P 536010

ON-SITE SEWAGE DISPOSAL SYSTEM HOWARD COUNTY HEALTH DEPARTMENT BUREAU OF ENVIRONMENTAL HEALTH

ADDRESS: 6565 MINK HOLLOW ROAD, HIGHLAND, MD 20777 PHONE NUMBER: 301-503-8079

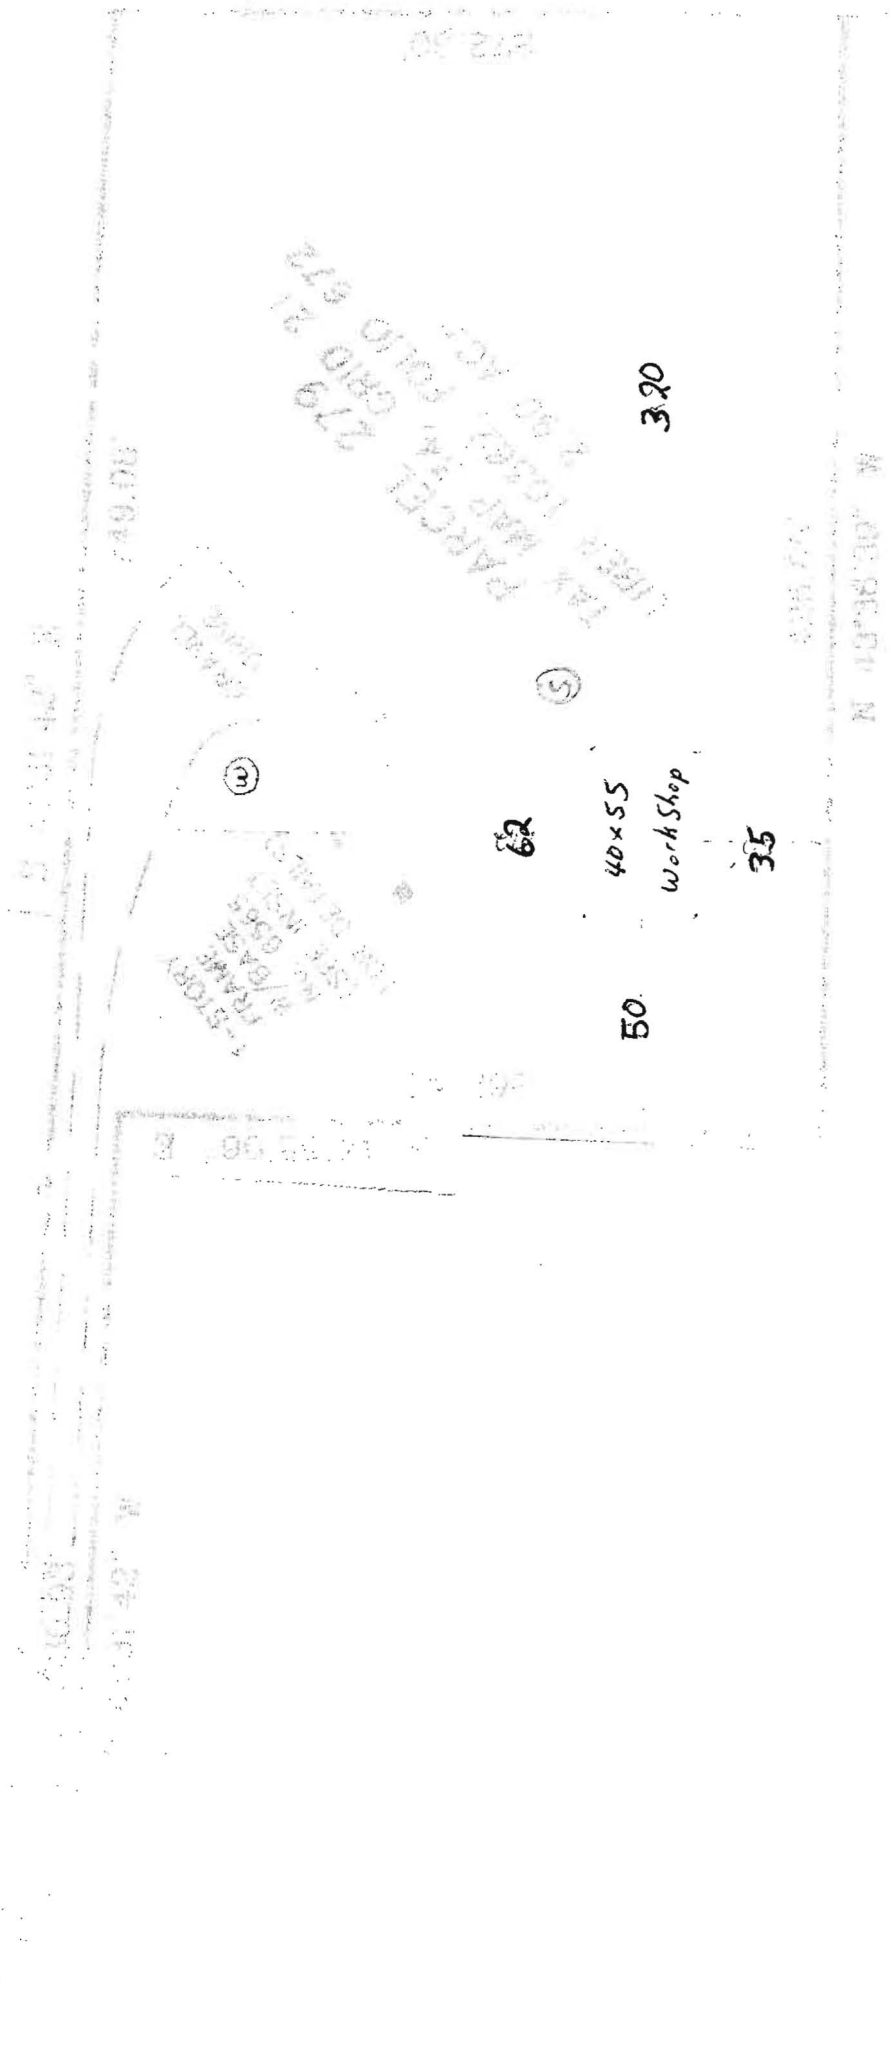
11/8/2011 Tank too deep to have an inlet of 4' for upper trench. Also trenches will be 1.5'-2' deeper on furthest end because it is uphill. Trench locations painted out. Must use laser or transit to dig trench bottoms. (BB)

11/8/2011 Working on top trench. Installer not keeping trench bottom level. Had them deeper uphill part of trench so that they would have sufficient sidewall. Told contractor again on how to use laser. (BB)
 11/9/2011 Contractor using laser on bottom trench. J.K. to finish and cover last 10' of trench. System finished. (BB)

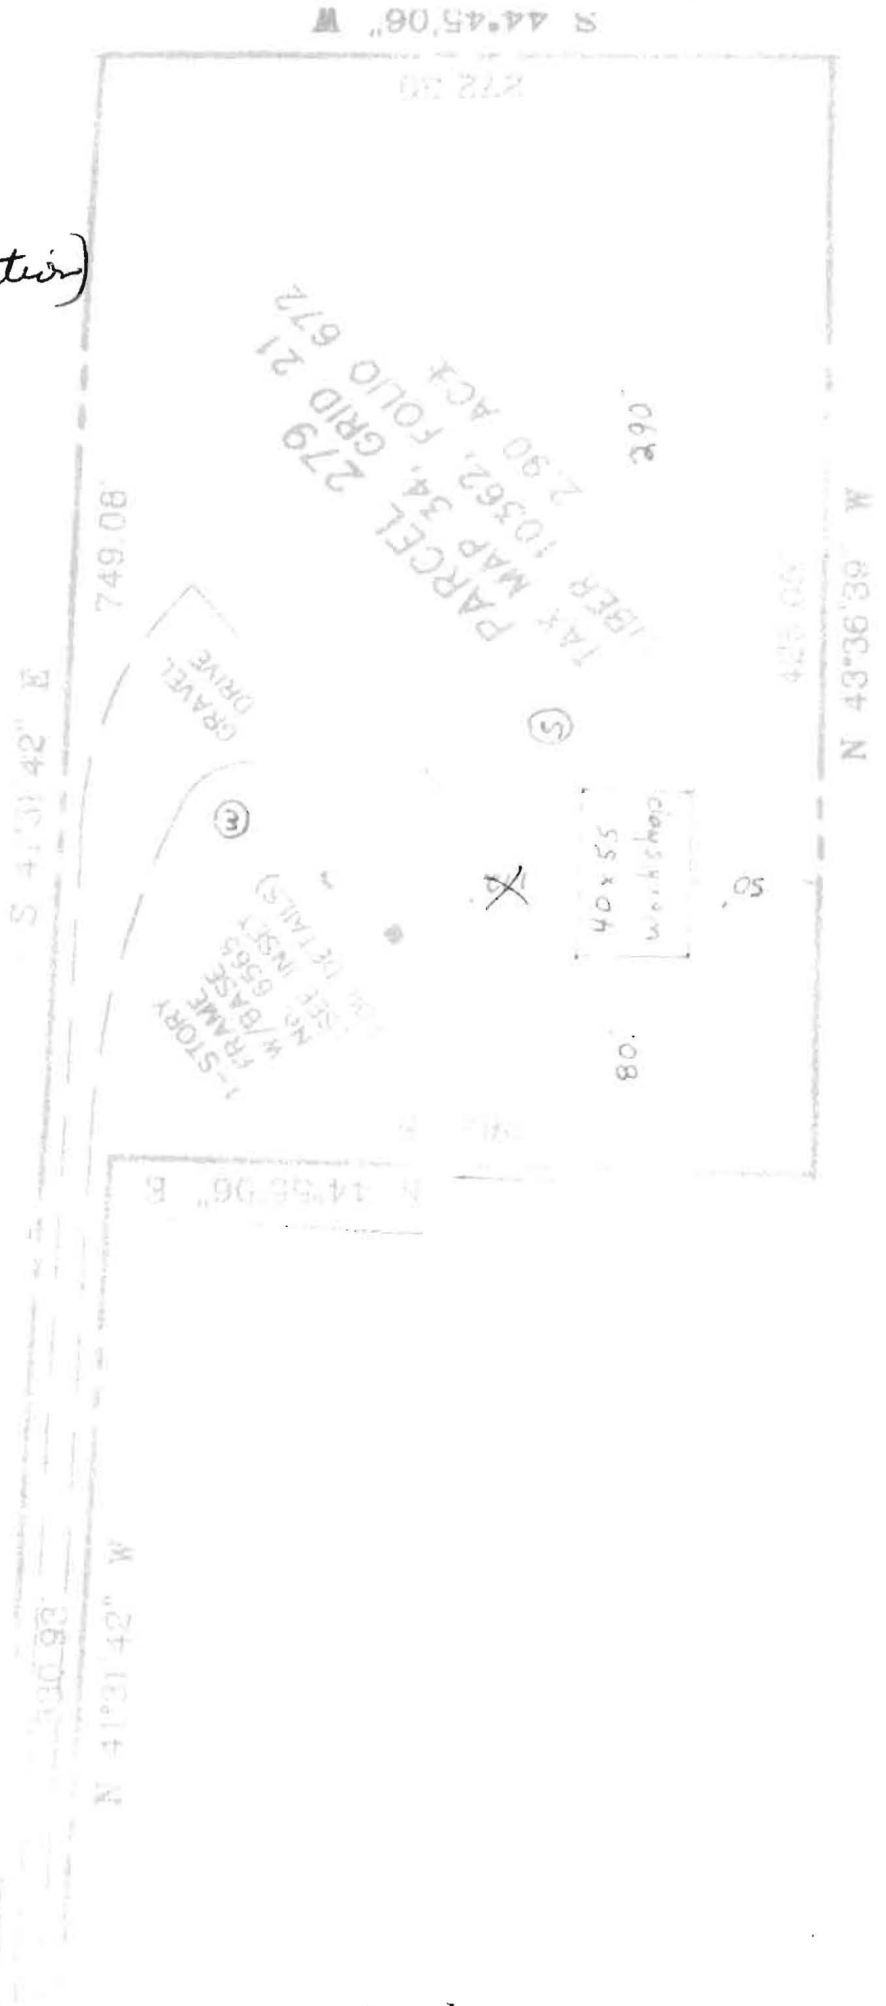
Septic tank (Exact location) trenches must be shown

LOCATION DIAGRAM

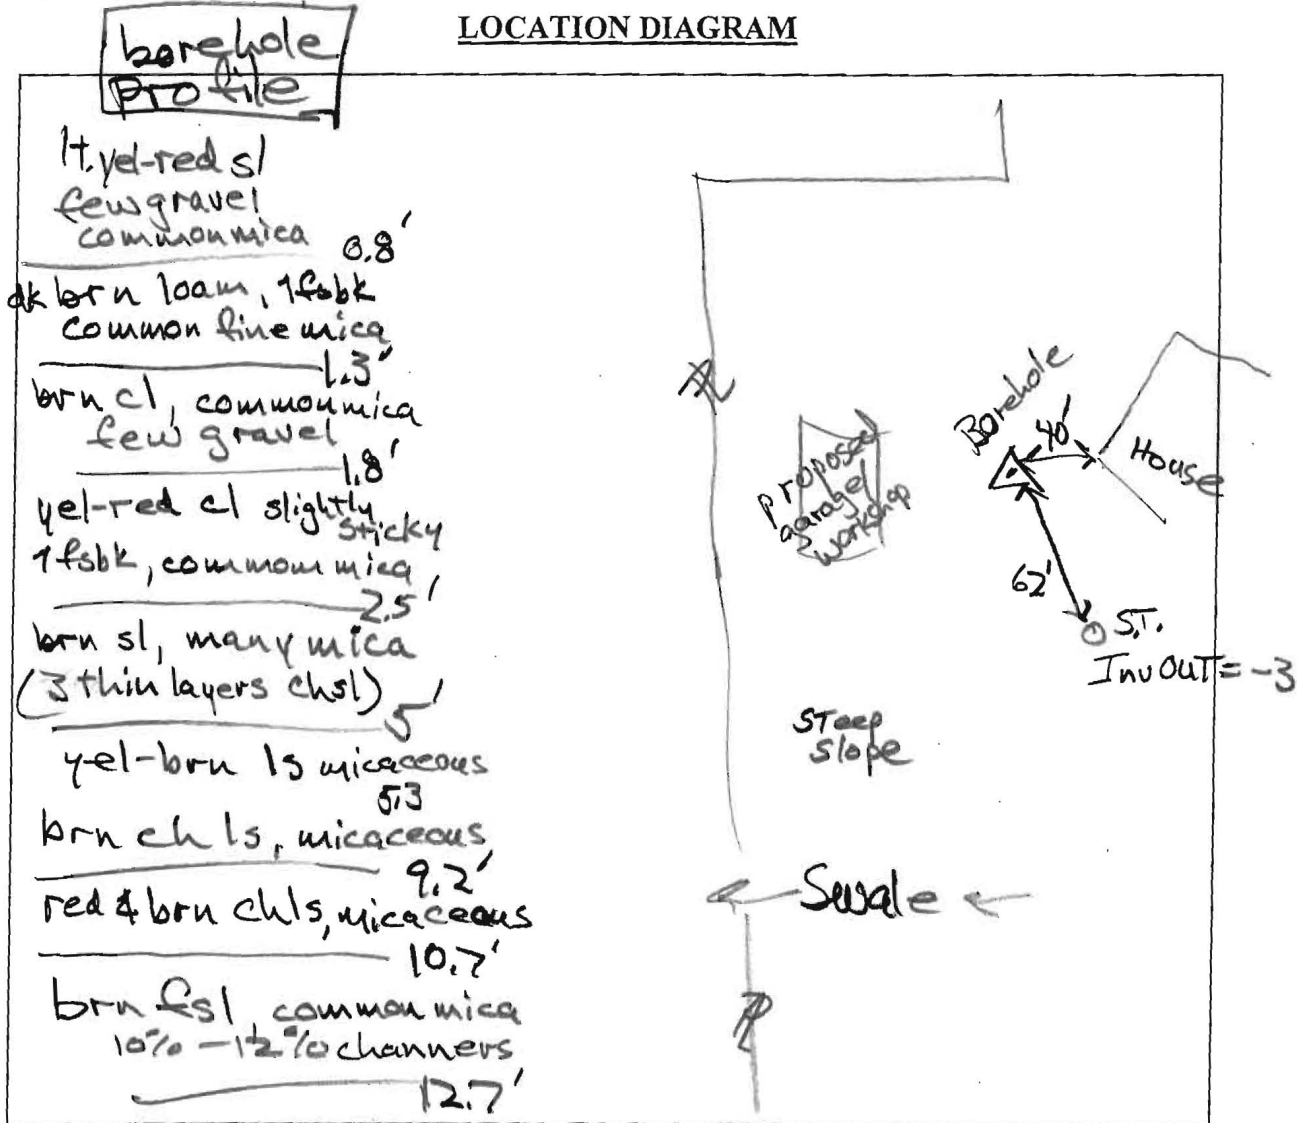
PROPOSAL: Hand-dug Borehole for soil profile description
In area perched in 1974.

COMMENTS: OK 2.5' - 8'+; 1.2 gpd/sq. ft.
